AS-CONSTRUCTED

ROAD AND STORM DRAINAGE CONSTRUCTION PLANS

WEST VILLAGE
RIVER CROSSING

CITY OF MILL CREEK
WASHINGTON

EXPIRES: 1/22/01
 7/1/99
 STAMP NOT VALID UNLESS SIGNED AND DATED
 JOB NUMBER: 96-321
 SHEET NUMBER: 4 OF 21

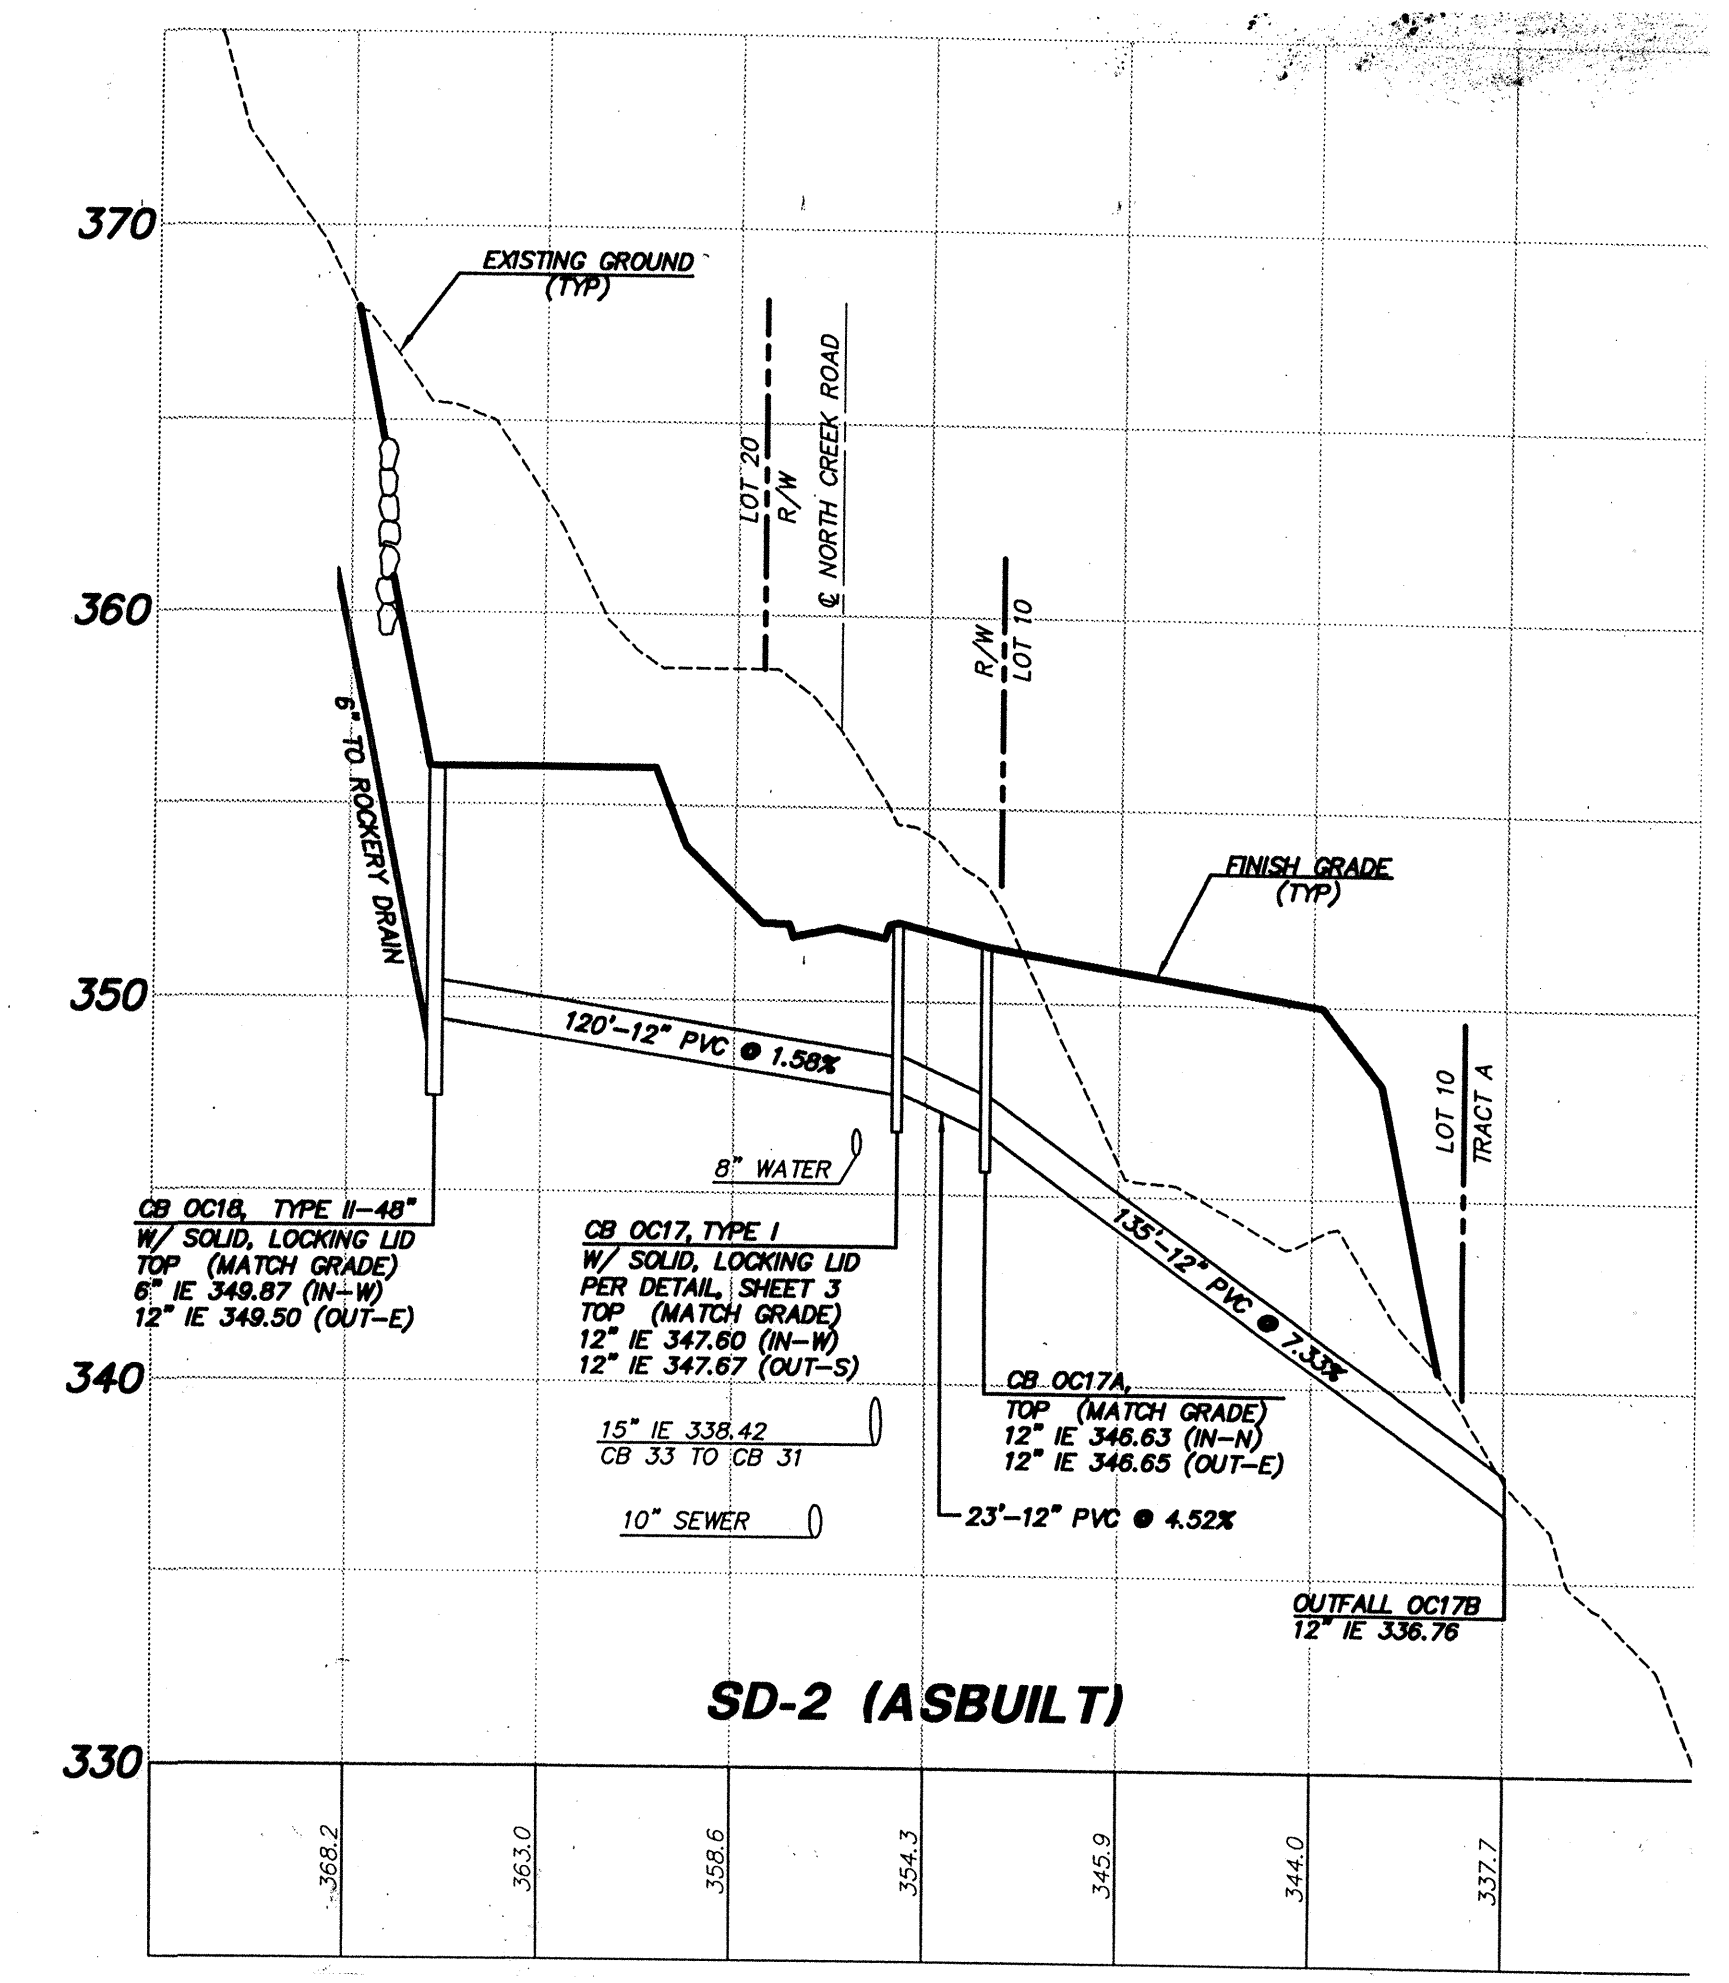
ASBUILT NOTE:
 RIMS NOT SET TO FINAL GRADE

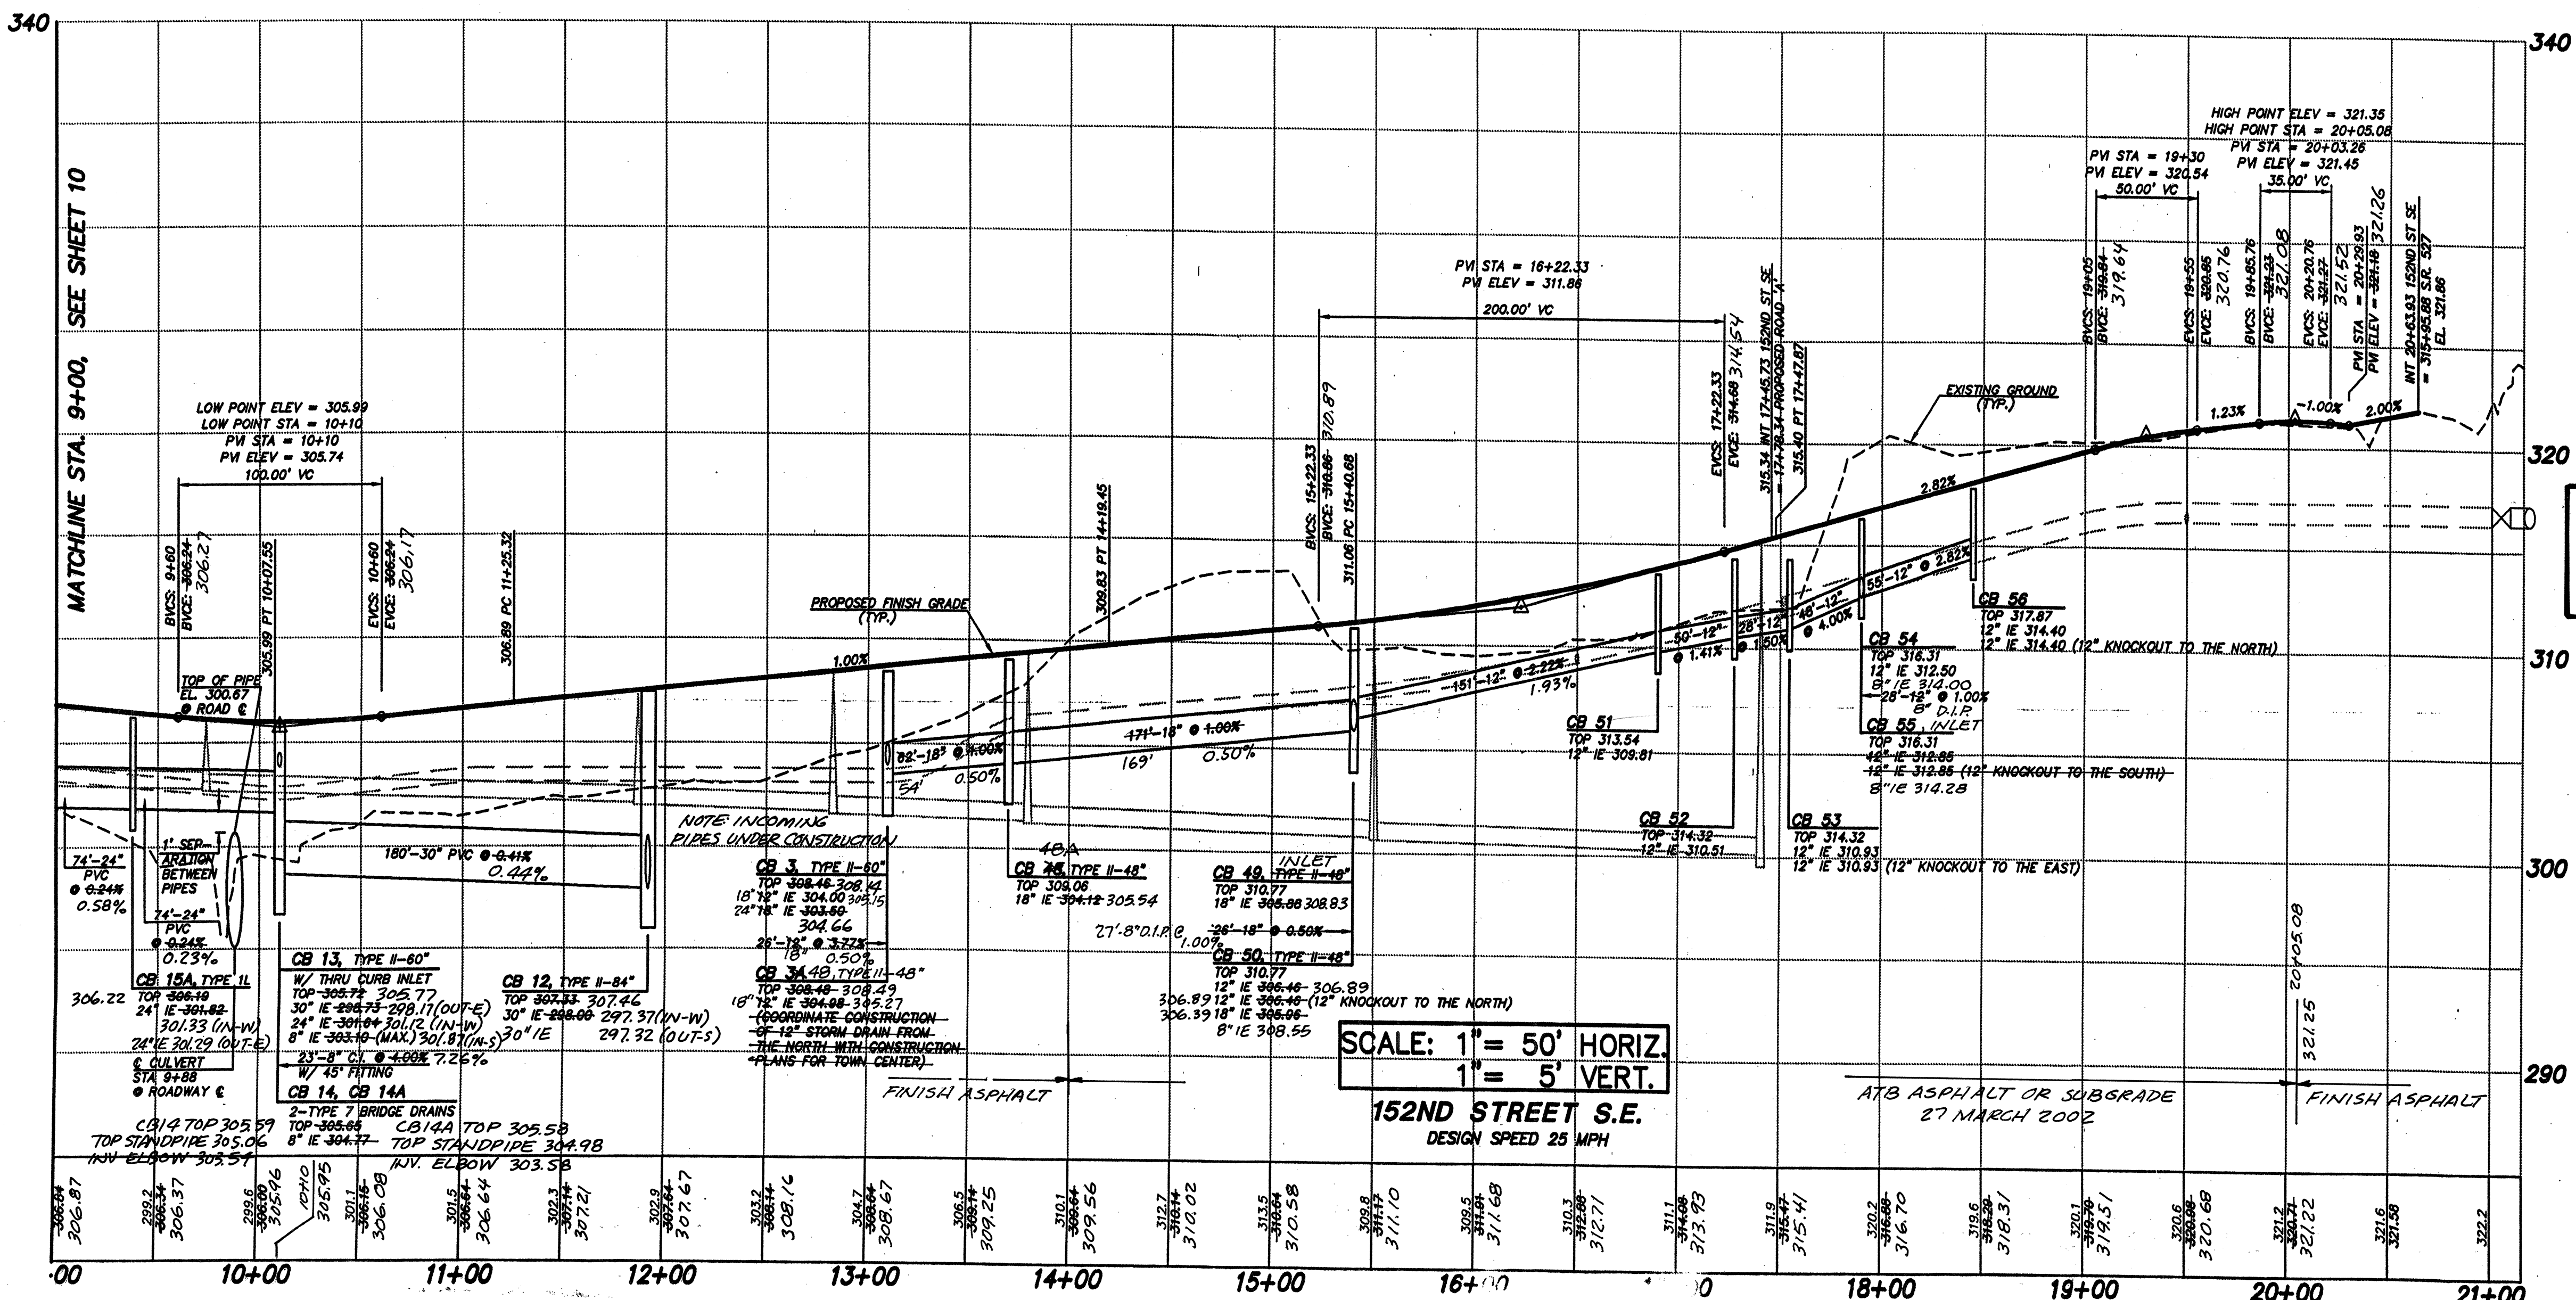
Approved with 2 exceptions
 Concrete curb/gutter detail not in plans and required
 Handrail detail required

PLAN VIEW
TYPICAL MEDIAN ISLAND DETAIL
NOT TO SCALE

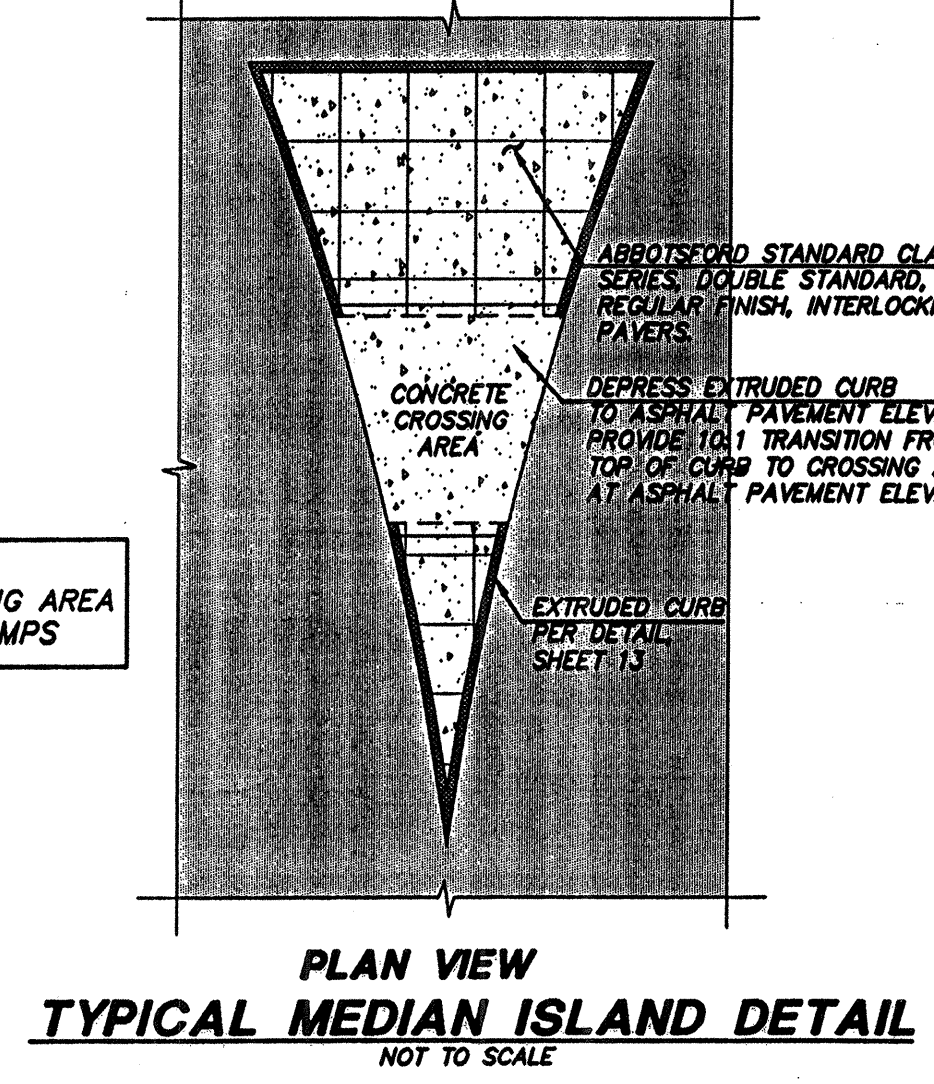
Island design is not approved
